Burlington Development Review Board

BURLINGTON DEVELOPMENT REVIEW BOARD

MEMORANDUM

To: Development Review Board
From: Mary O'Neil, AICP, Principal Planner
Date: ~~April 21, 2020~~ June 16, 2020
RE: ZP20-0773CU, 10 Baird Street

SCALE: 1" = 10' HOR.
1" = 10' VERT.

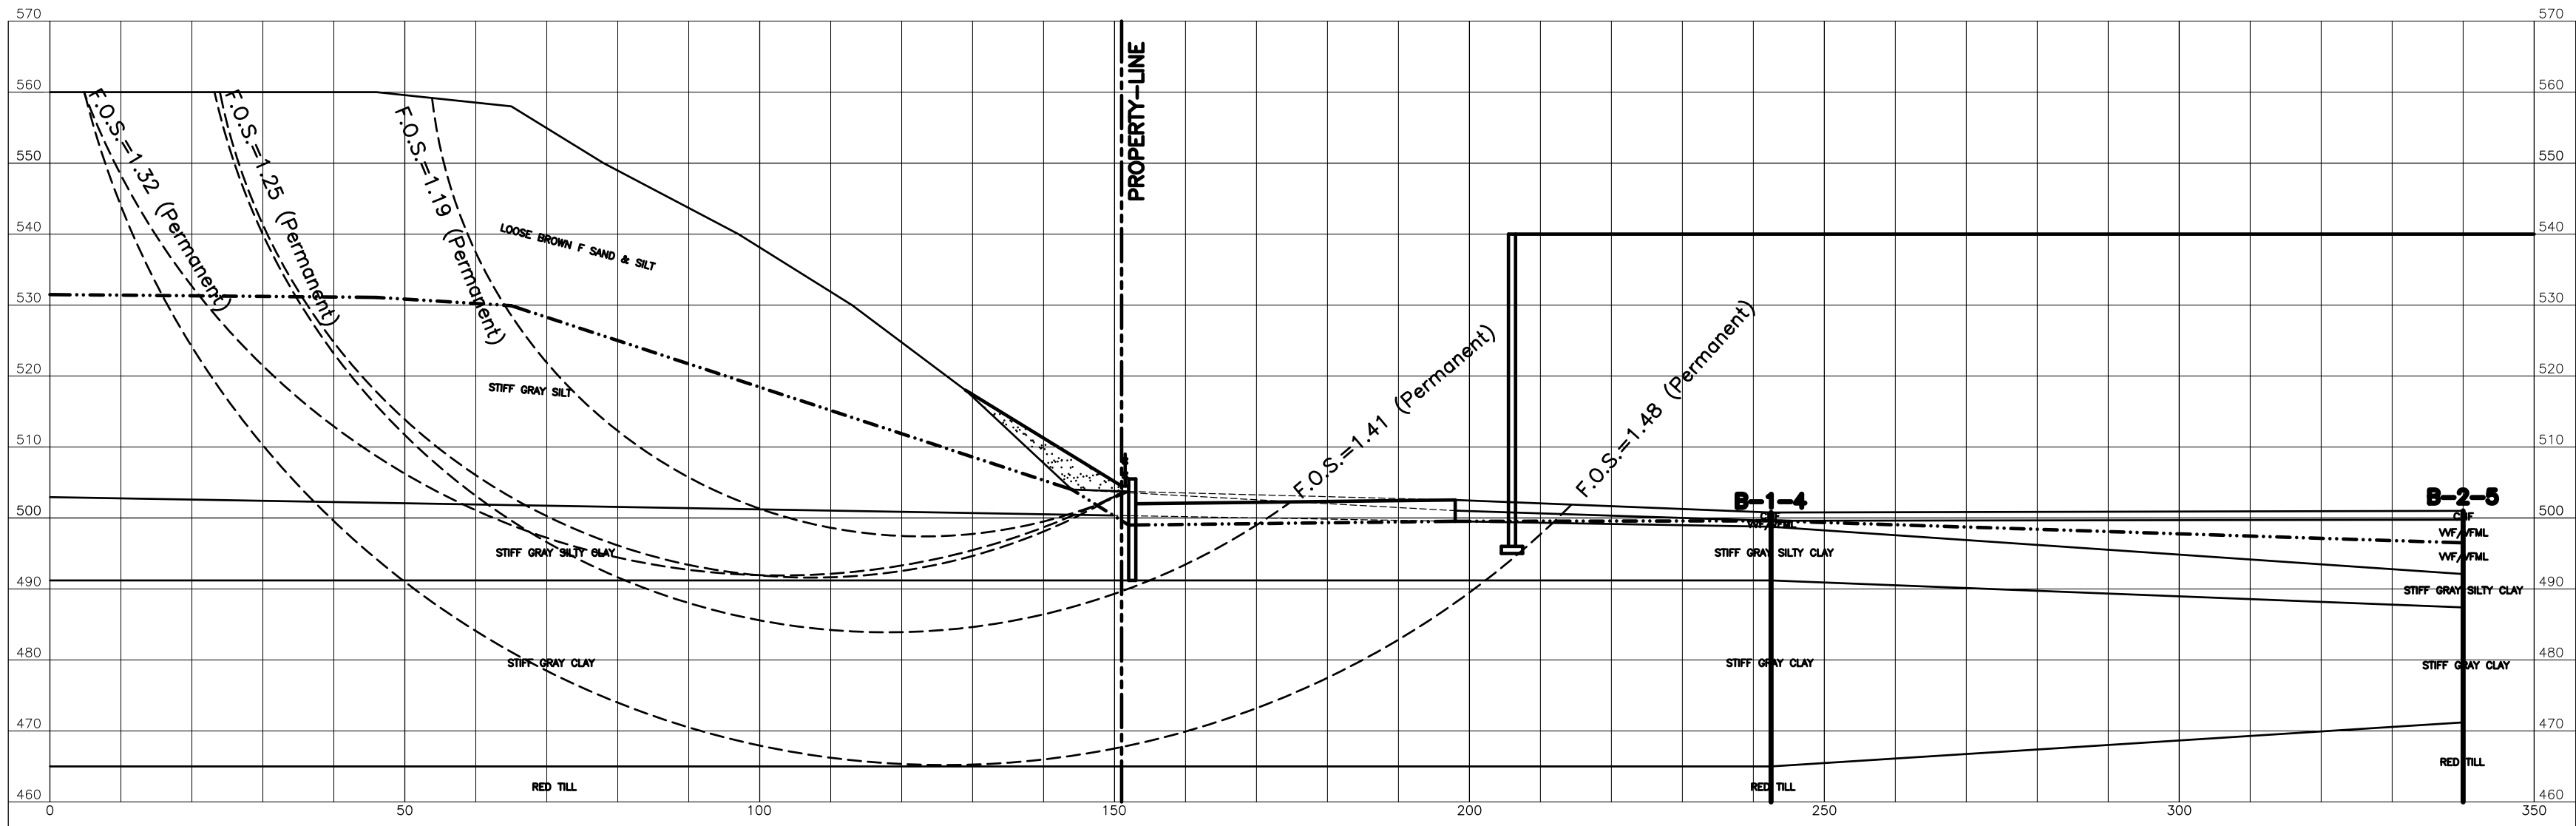
As required, geotechnical details have been provided as to the proposed retaining walls behind the building. Significant cut into the bank is proposed. Sheet piling will hold back the bank to allow space for the building and related parking. Site plan details, elevations, cross sections, and anchoring details have been provided. All have been provided by a Vermont licensed engineer. The City Engineer has reviewed the shoring plans and has identified only one remaining issue as to property rights to install and maintain the retaining wall system with neighboring properties. A draft easement with the adjoining property for anchoring and maintaining the proposed retaining wall has been submitted for review. The applicant requests that execution of the easement be a condition of approval. **Affirmative finding as conditioned.**

SCALE: 3/32" = 1'-0"
DATE: FRN
DRAWN BY: SCG
CHECKED BY: SCG
PROJECT: -
SHEET TITLE:
BASEMENT
PARKING
PLAN
DRAWING NO.
A1-1

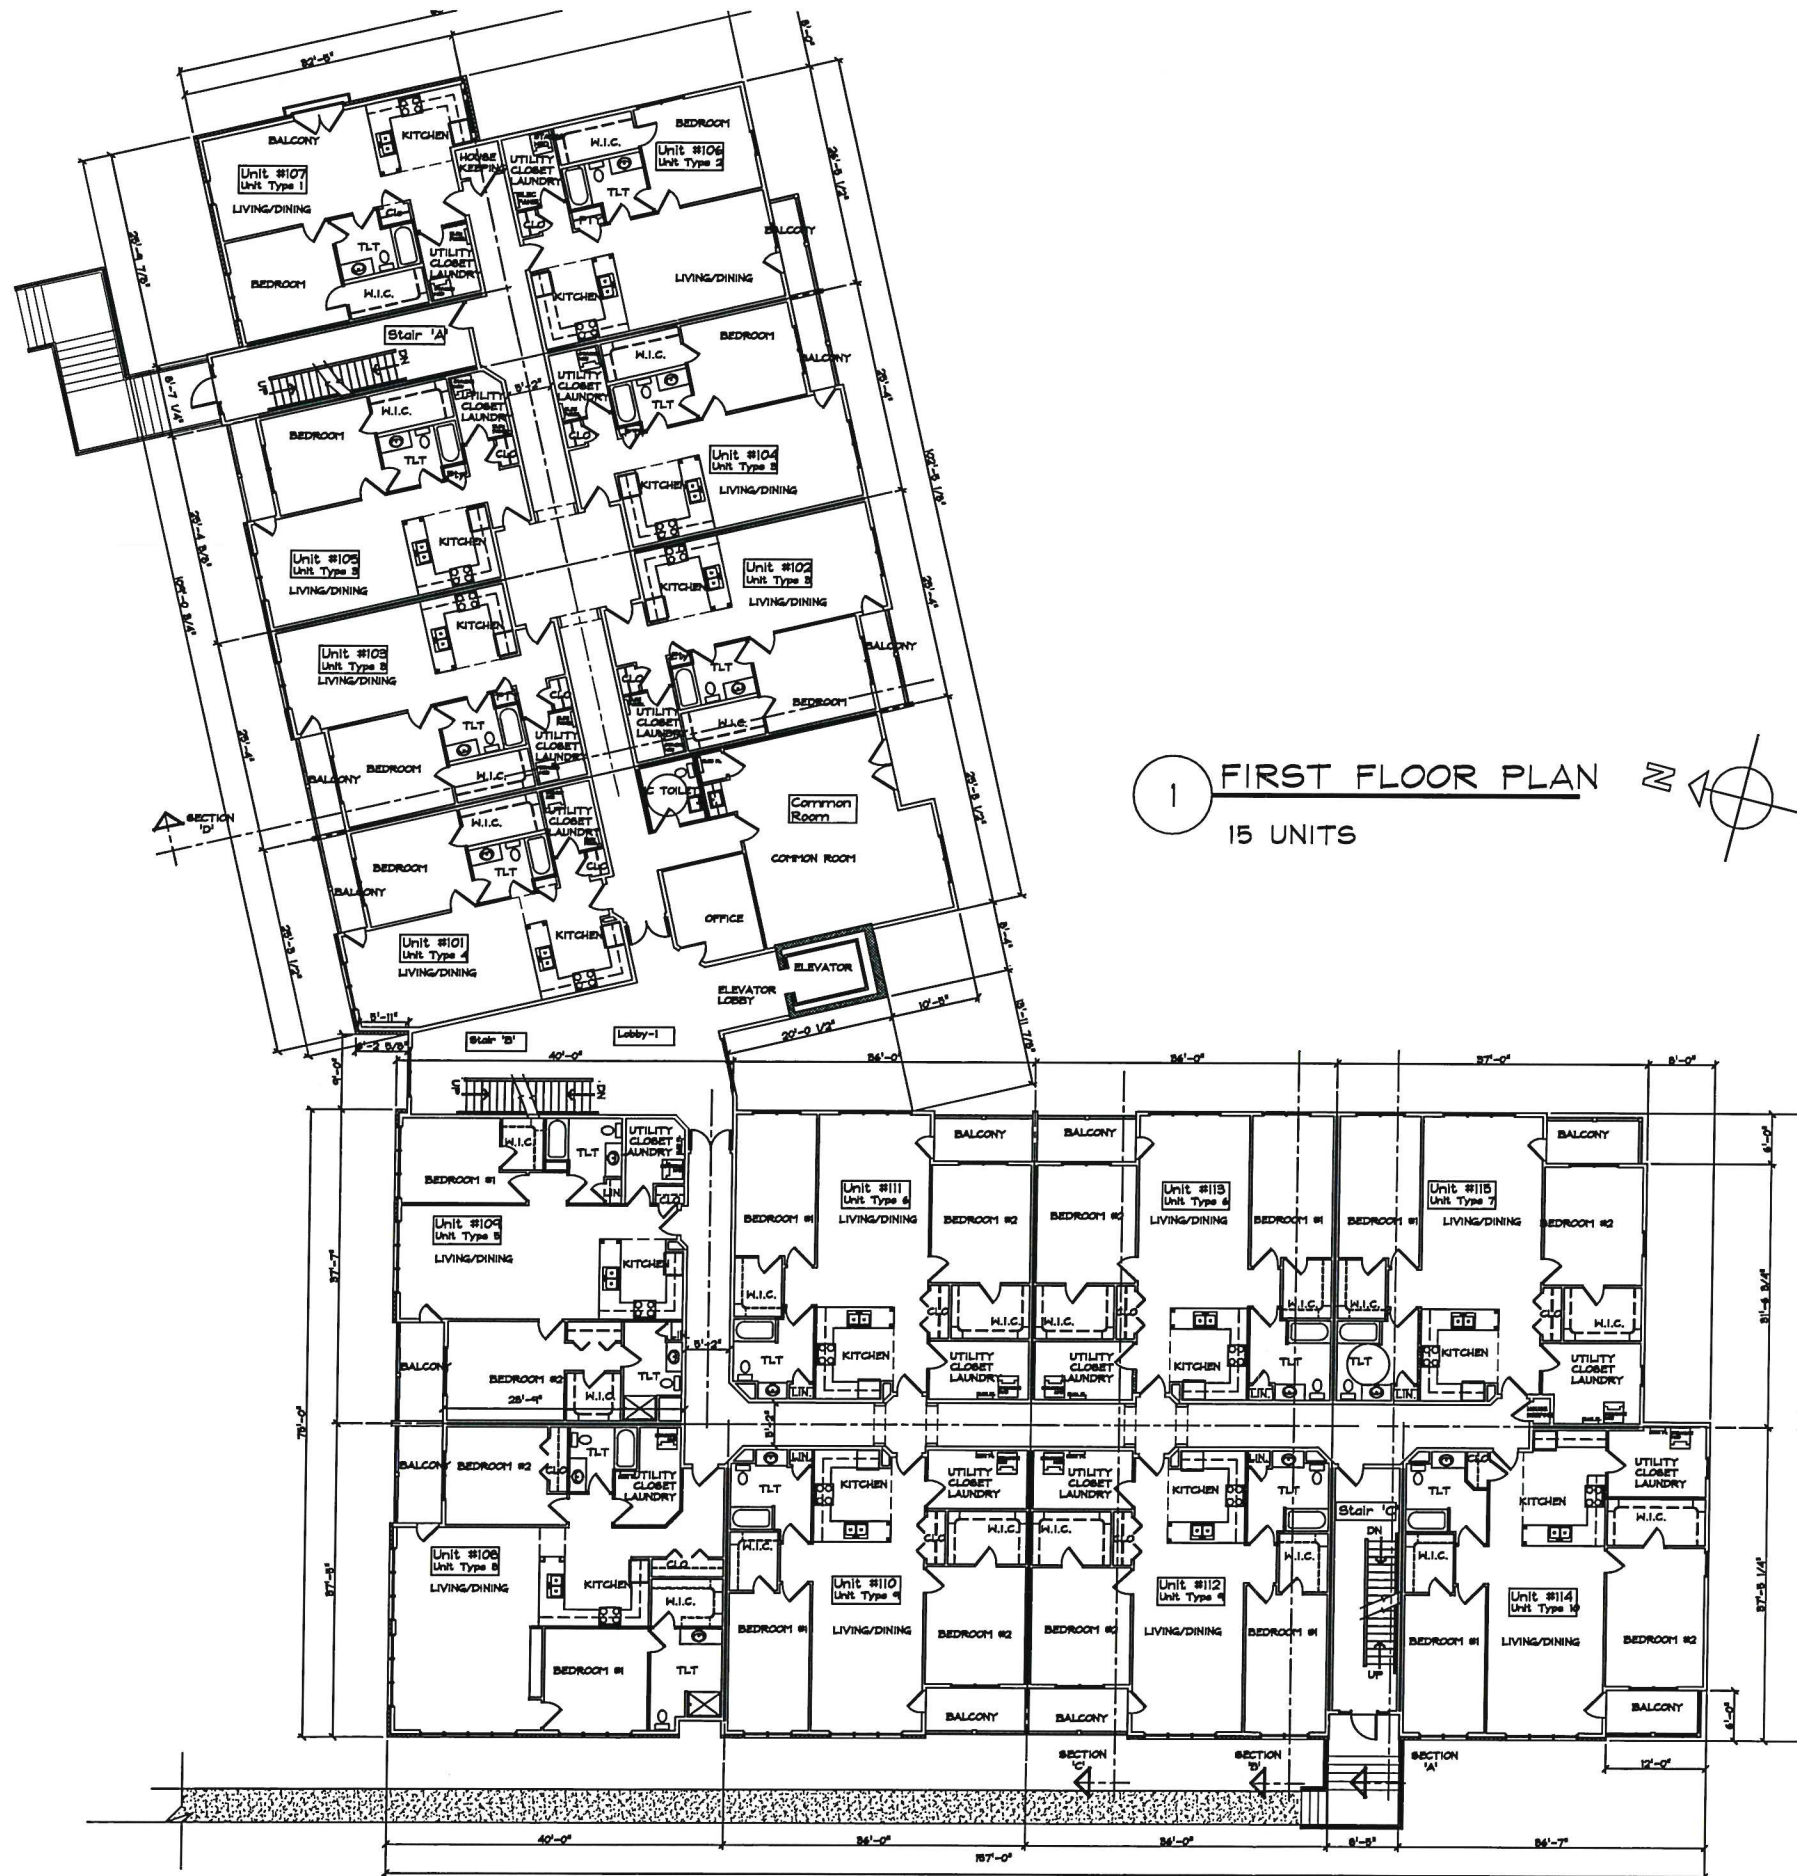
(Revised parking, Plan A1-1. 8/1/19). 25% of the units (14) are intended to be low to moderate income Senior Housing to qualify for the additional height bonus.

SF of Project	88,772	Based on Drawing A1-1
	<u>Residential</u>	
Department	Rate	Fee
Traffic	0.196	17,399.31
Fire	0.222	19,707.38
Police	0.044	3,905.97
Parks	0.743	65,957.60
Library	0.460	40,835.12
Schools	0.961	85,309.89
Total	2.626	\$ 233,115.27

The applicant has agreed to dedicate 25% of the proposed (57) residential units to low-moderate seniors, with 10% of those reserved for low-income senior households, to achieve an additional 10' in height and corresponding FAR. The proposal exercises the height bonus within this application. Plan A1-1 details the gross floor area of the fourth floor (bonus allowance) as 13,066

The applicant shall provide an annotated floor plan to identify the senior housing units to assure the equivalent gross floor area (13,066 sq. ft.) with the gross floor area achieved through the height bonus. Although the entire fourth floor is identified as Senior Housing, an additional four units for a total of 14 are required to secure the height bonus. **Affirmative finding as conditioned.**
